NEW YORK STATE THRUWAY AUTHORITY
DEPARTMENT OF ENGINEERING

AMENDMENT NO. 1
TO

CONTRACT TAA 25-6B
D215009
REHABILITATION OF NYS THRUWAY (I-90)
BRIDGE OVER NYS ROUTE 5S / ERIE
CANAL RAIL TRAIL
AT MILEPOST 178.38
IN THE ALBANY DIVISION
IN MONTGOMERY COUNTY

CONTRACT NUMBER: TAA 25-06B
 DATE: 12/6/2024
 DRAWING NUMBER: WZSD-1

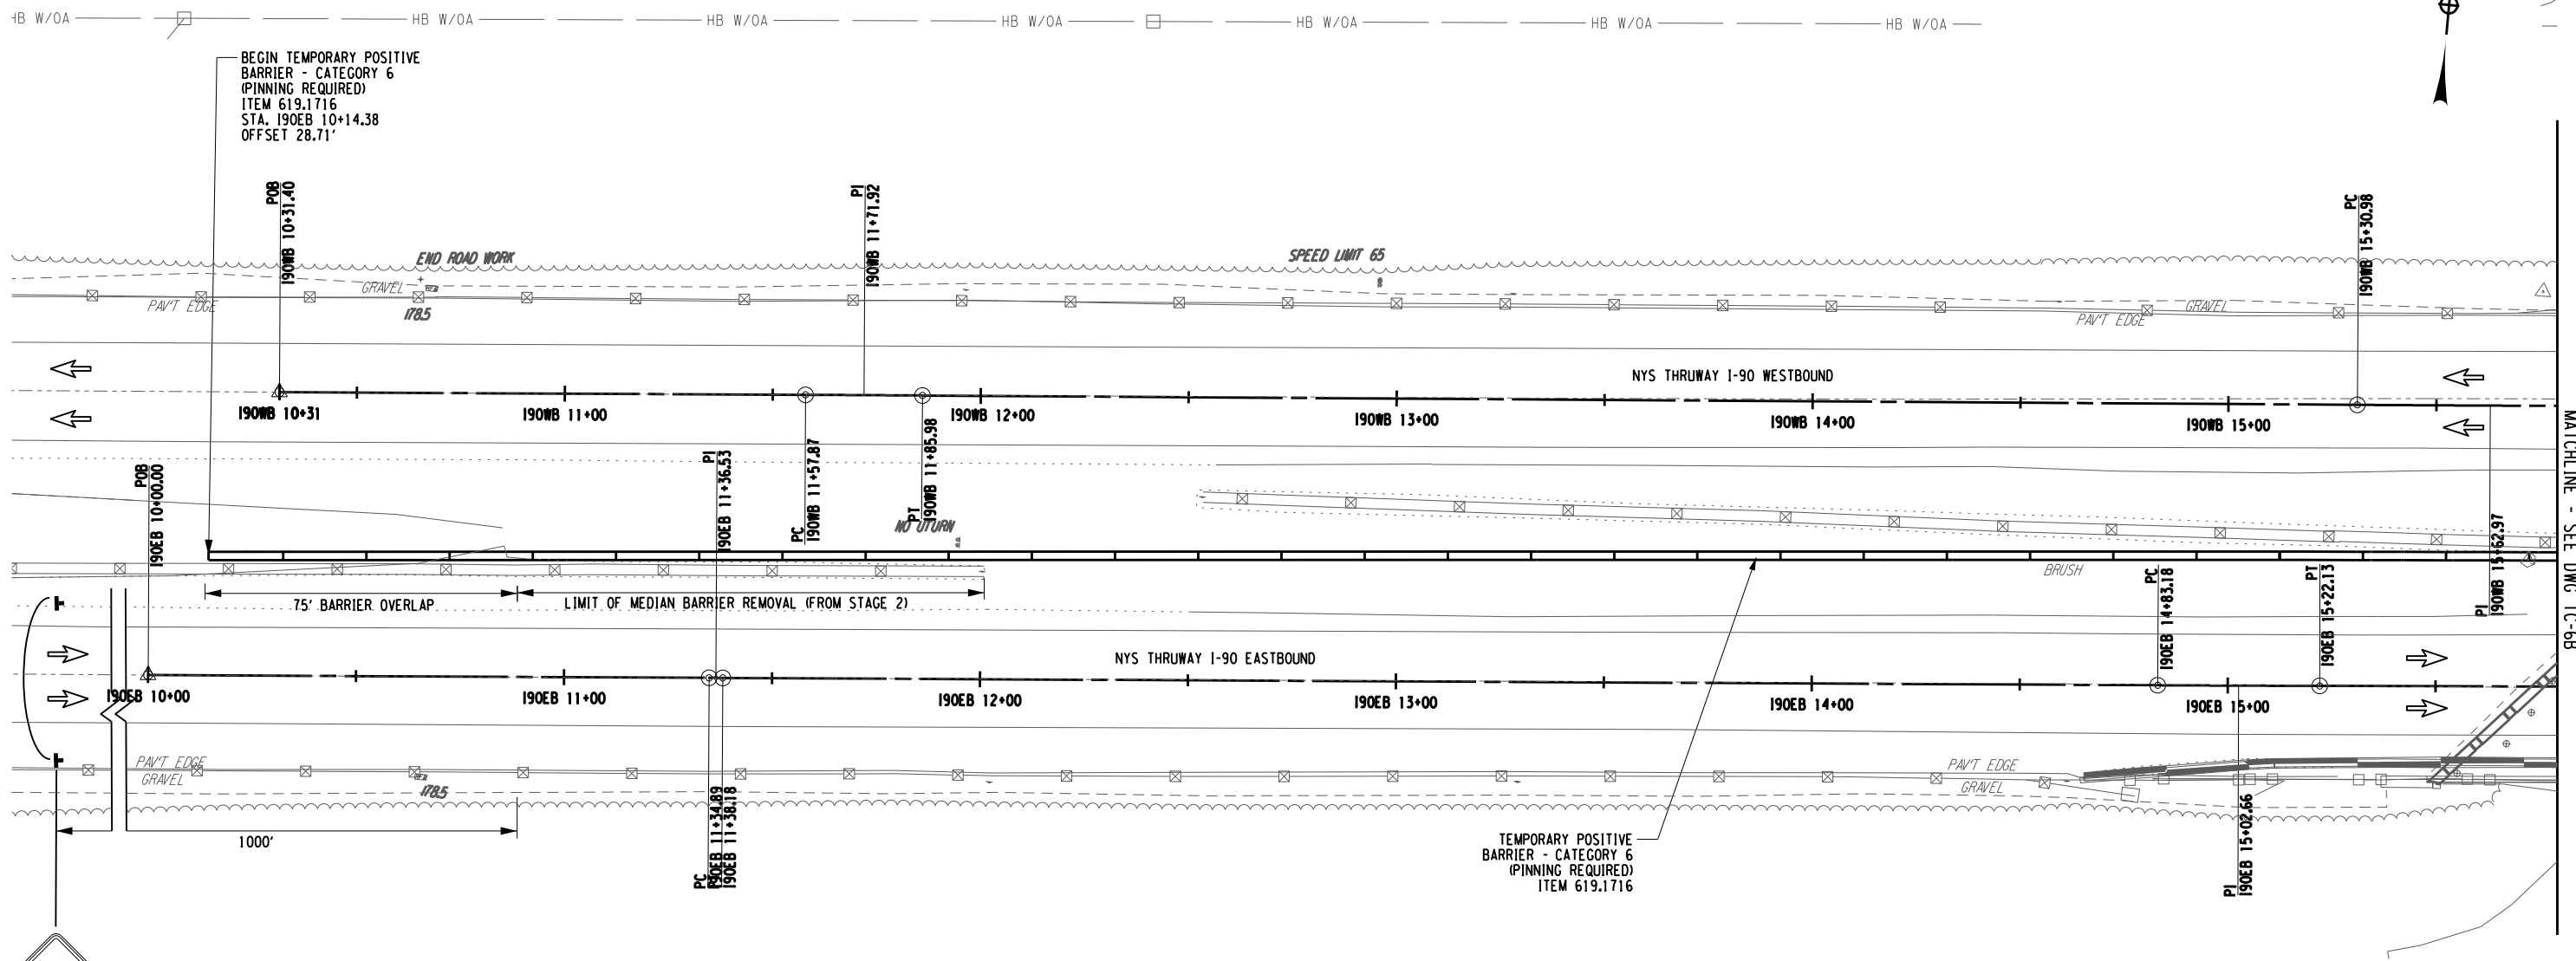
11. **DELETE** Drawing Number WZSD-1, sheet 13 of 95, and **SUBSTITUTE** with the attached Drawing Number WZSD-1, Sheet 13-A1 of 95. The "Road Work Ahead" sign has been added to the table.

CONTRACT NUMBER:
TAA 25-06B
 DATE:
12/6/2024
 DRAWING NUMBER:
TC-6A

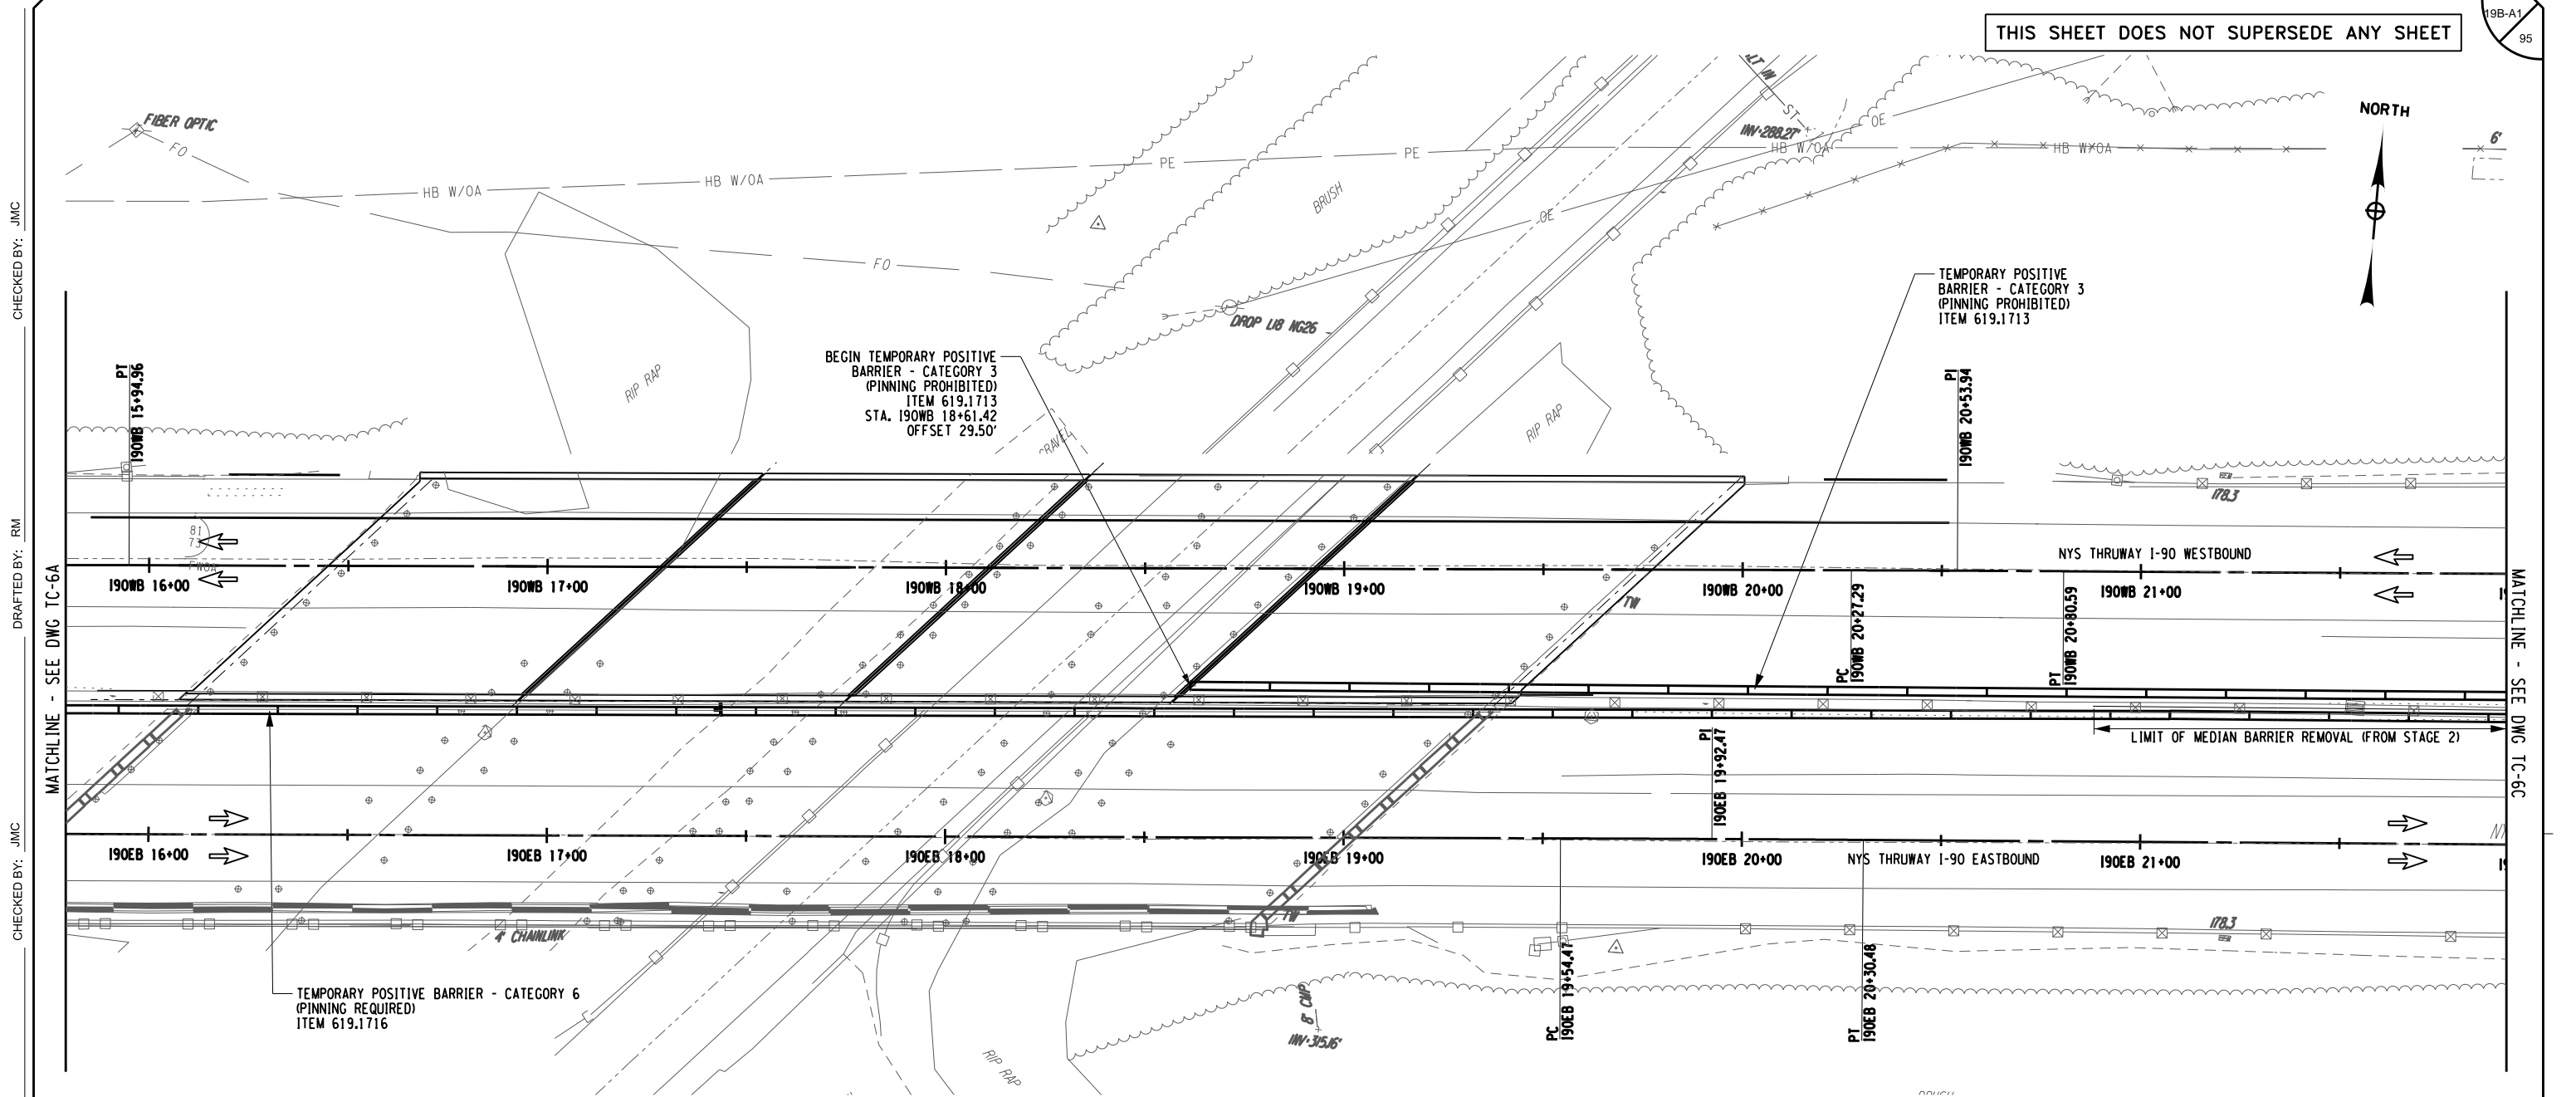
12. **ADD** Drawing Number TC-6A, sheet 19A-A1 of 95. This sheet was added to provide a Work Zone Traffic Control Layout for the Winter Shutdown.
13. **ADD** Drawing Number TC-6B, sheet 19BA-A1 of 95. This sheet was added to provide a Work Zone Traffic Control Layout for the Winter Shutdown.

DRAWING NUMBER:
TC-6C

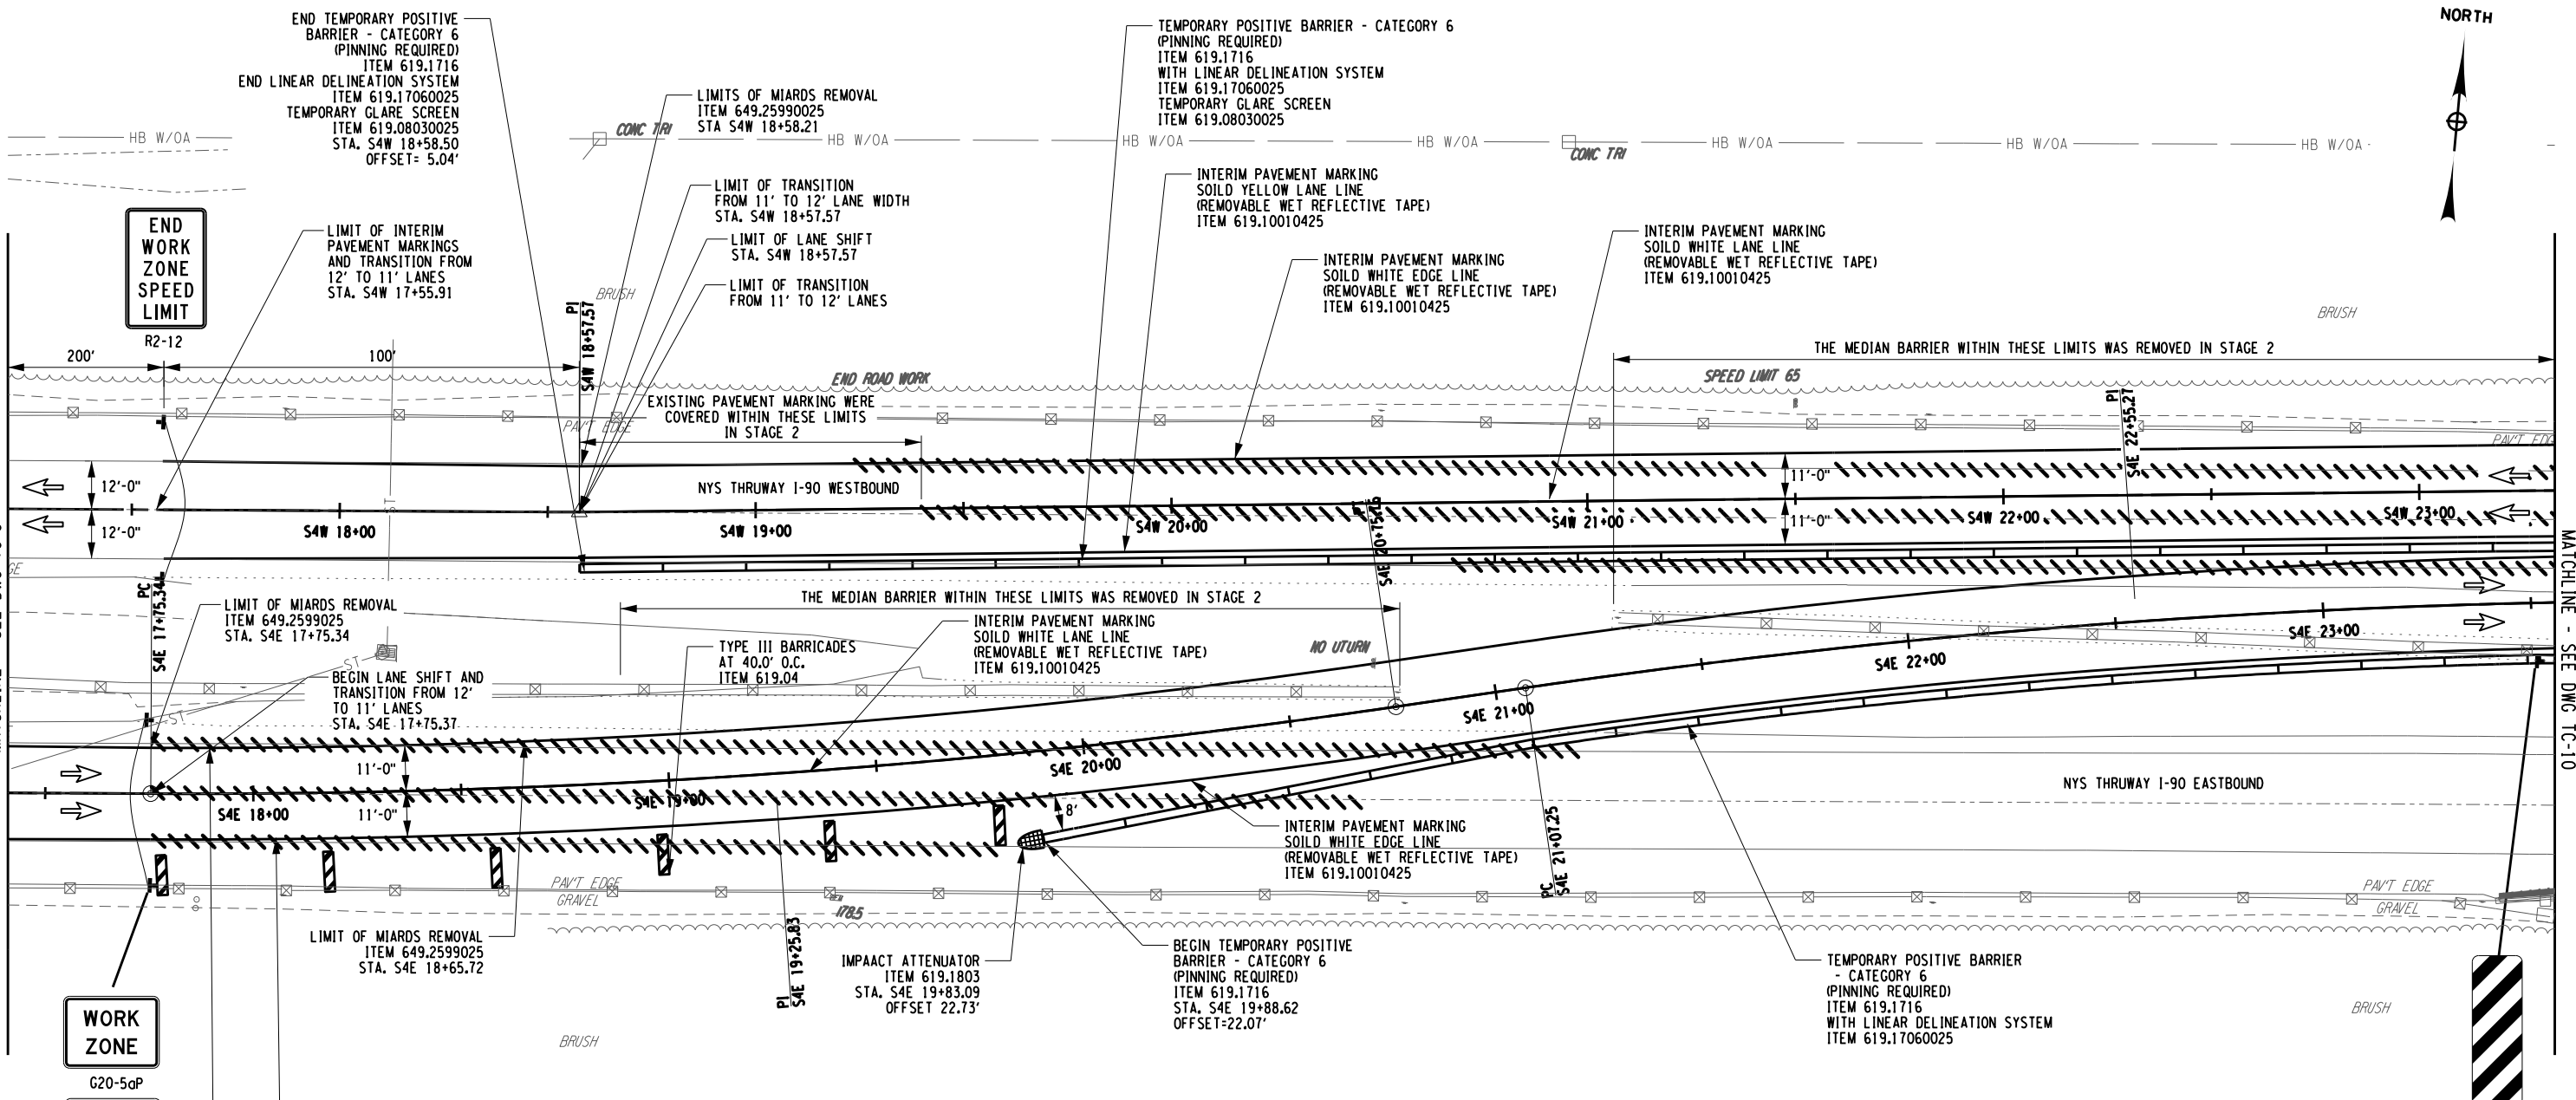
14. **ADD** Drawing Number TC-6C, sheet 19CA-A1 of 95. This sheet was added to provide a Work Zone Traffic Control Layout for the Winter Shutdown.
15. **DELETE** Drawing Number TC-9, sheet 22 of 95, and **SUBSTITUTE** with the attached Drawing Number TC-9, Sheet 22-A1 of 95. Removed notation indicating existing pavement markings on the Mainline Eastbound lanes were previously covered in Stage 2.

| TITLE OF DRAWING WORK ZONE TRAFFIC CONTROL STAGE 4 | DRAWING NUMBER: TC-11 |

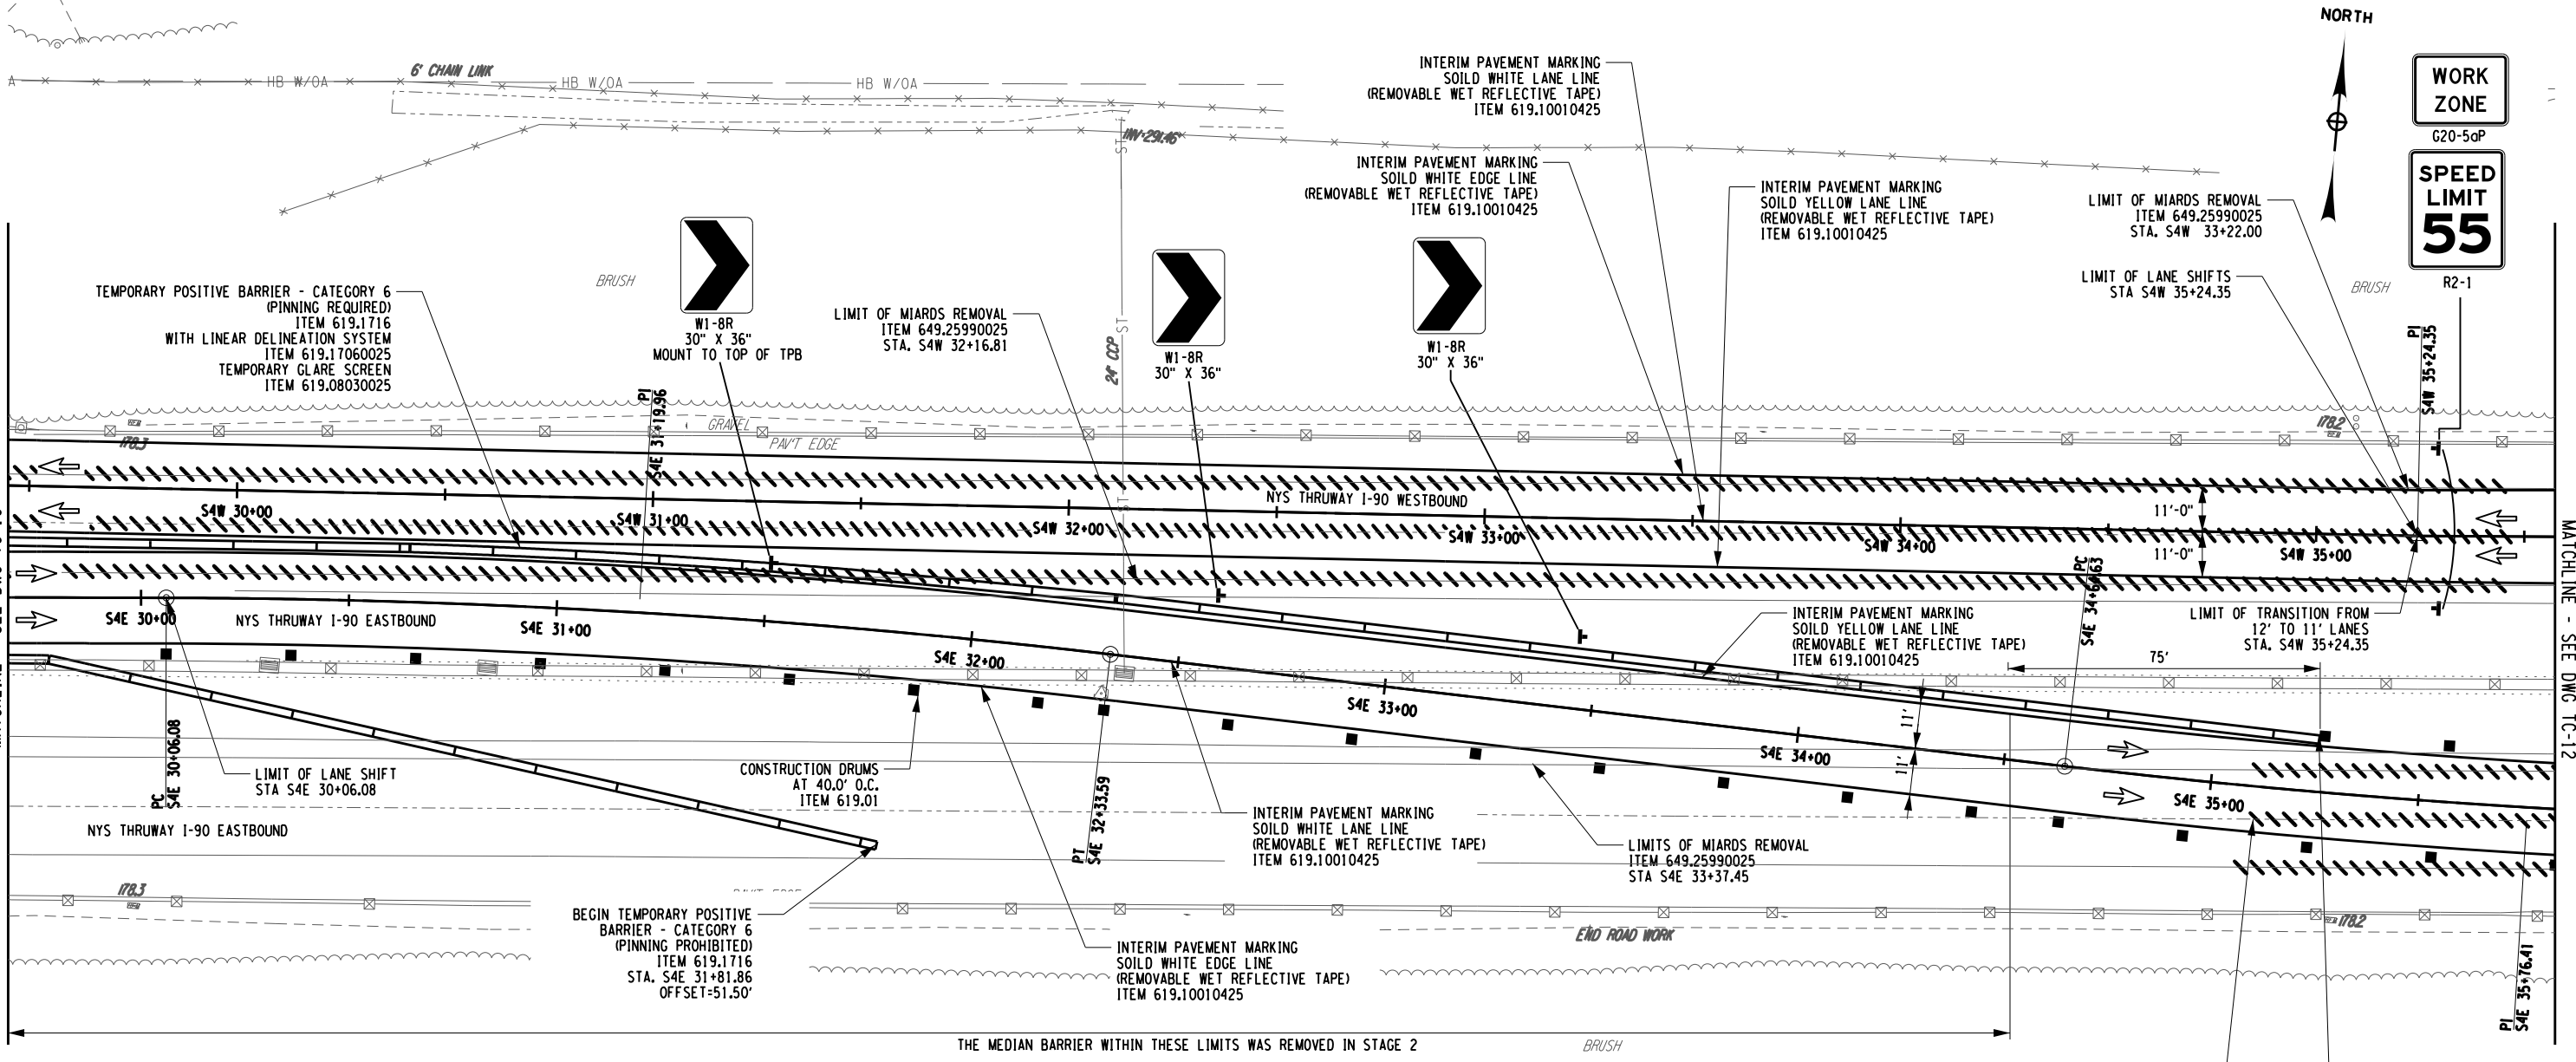
16. **DELETE** Drawing Number TC-11, sheet 24 of 95, and **SUBSTITUTE** with the attached Drawing Number TC-11, Sheet 24-A1 of 95. Removed notation indicating existing pavement markings on the Mainline Eastbound lanes were previously covered in Stage 2.
